SERVICE BULLETIN

No. 704

Piper Aircraft Corporation

Cabin Fan Fuse Installation

Schematic for PA-31, PA-31-325, PA-31-350

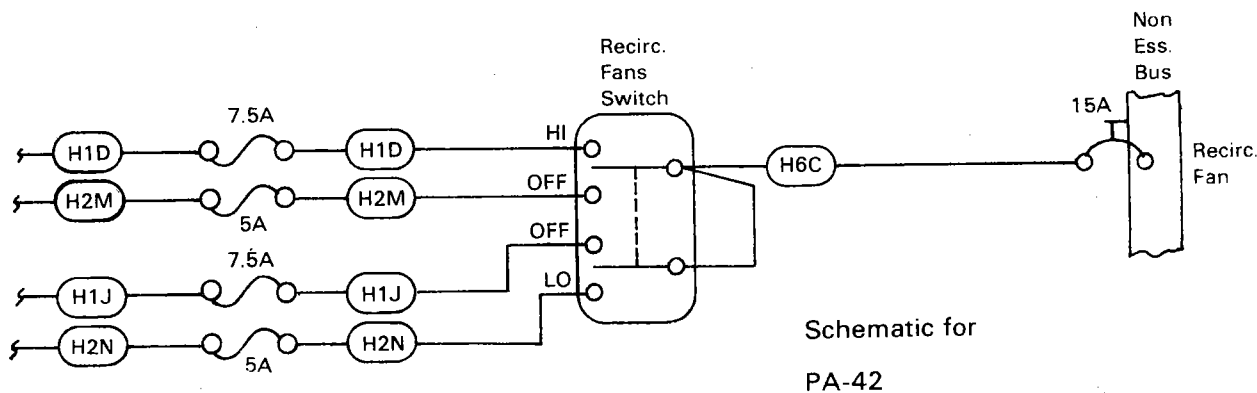
Purpose: There have been reports from the field of shorted field windings in the recirculation blower motors, which in some cases may not trip the circuit breaker. This failure may cause varying amounts of smoke and/or fumes in the cabin and cockpit.

This Service Release provides instructions for the addition of individual fuses in the blower motor circuit. These fuses when installed will open the circuit in the event of a malfunctioning motor and prevent wire overheating and smoke.

1. Lower overhead switch panel to gain access to the "Recirculation Fans" switch.
2. Locate the back of the "Recirculation Fans" switch and its associated wires per Sketch "A".
3. Cut wires H2C, H2D, H2E and H2F at a convenient distance from the switch, and solder a Piper part number 461 628 (HHJ-A) fuse holder on each of the wires. Reference Sketch "B".
4. Install a Piper part number 461 623 (AGC-5) fuse in the fuse holders for wires H2C and H2E, and a Piper part number 461 632 (AGC-7 1/2) fuse in the fuse holders for wires H2D and H2F.
5. Tie up fuse holders as necessary and reinstall the overhead panel.
6. Log compliance with this Service Release in aircraft logbook.

Schematic for
PA-31T2

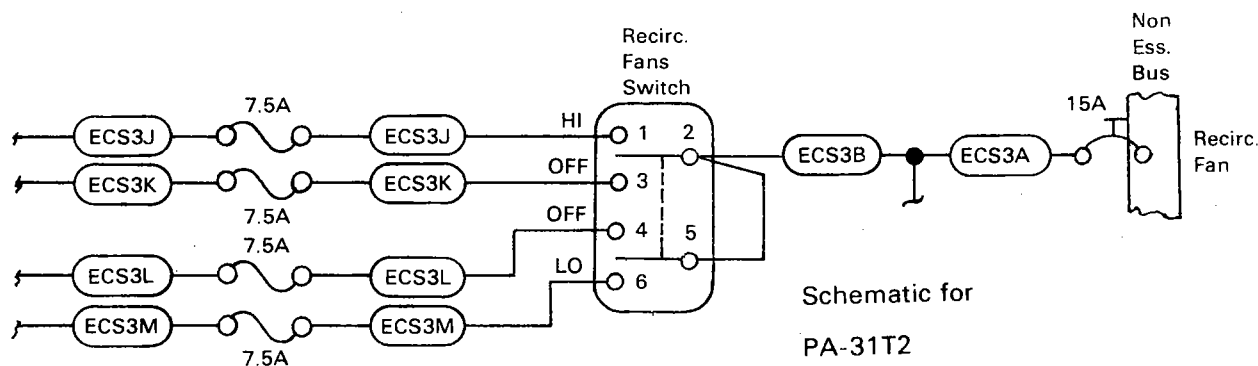
1. Remove the lower right electroluminescent panel and remove the cabin fan switch. If the Hartzel Synchrophaser System has been installed, it may also be necessary to drop the computer box just under, and forward of where the switch is installed.
2. Drop the cabin fan switch below the panel and loosen the cables enough to gain access to wires ECS3J, ECS3K, ECS3L and ECS3M.
3. Cut the aforementioned wires a convenient distance from the switch, and solder a fuse holder, Part number 461 628 (HHJ-A), in each of the lines. Refer to Sketch "B".
4. Install a 7.5 amp fuse, Part Number 461 632 (AGC-7 1/2), in each of the lines.
5. Tie up the wires as necessary, and reinstall the switch, electroluminescent panel, and other hardware removed.
6. Log compliance with this service release in the aircraft logbook.

SKETCH "A"

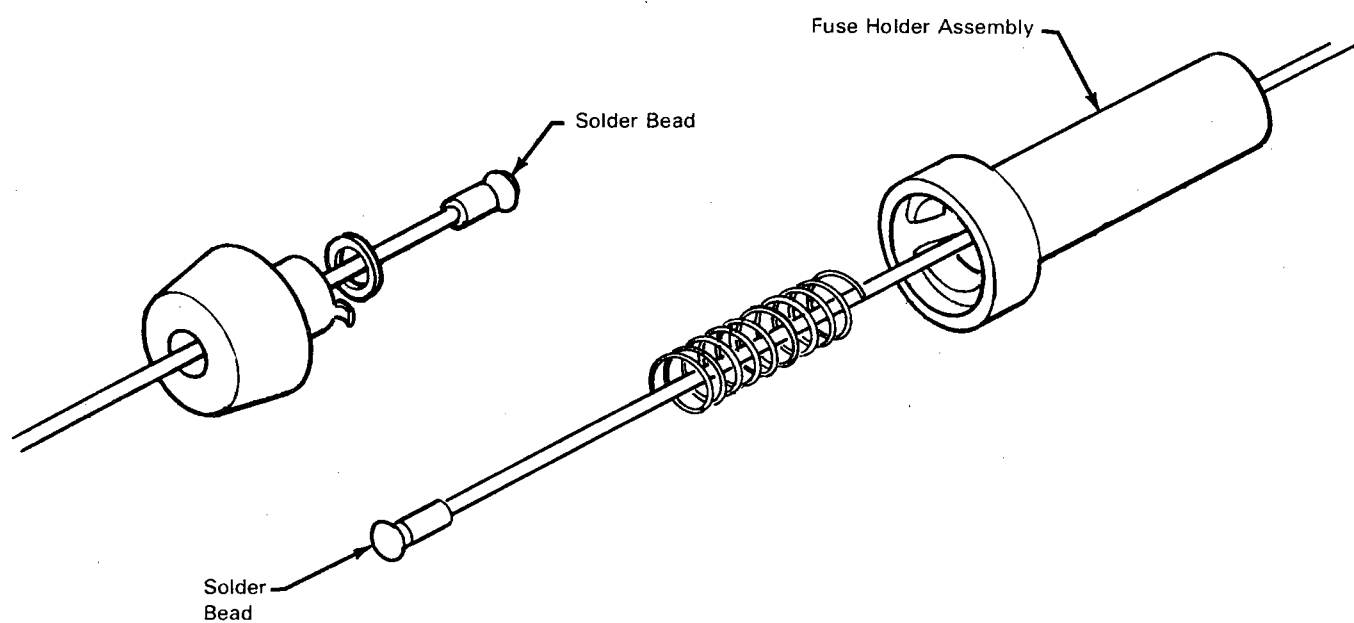
1. Remove the lower right electroluminescent panel Piper Part number 71197-04, and remove the cabin fan switch, Piper Part number 588 056 from the instrument panel.
2. Locate the back of the "cabin fan" switch and its associated wires per Sketch "A".
3. Cut wires H1D, H1J, H2N and H2M a convenient distance from the switch and solder a Piper Part Number 461 628 (HHJ-A) fuse holder on each of the wires. Reference Sketch "B".
4. Install a Piper Part number 461 623 (AGC-5) fuse in the fuse holders for wires H2M and H2N, and a Piper Part number 461 632 (AGC-7 1/2) fuse in the fuse holder for wires H1D and H1J.
5. Tie up wires as necessary, and reinstall switch and electroluminescent placard onto instrument panel.
6. Log compliance with this Service Release in aircraft logbook.
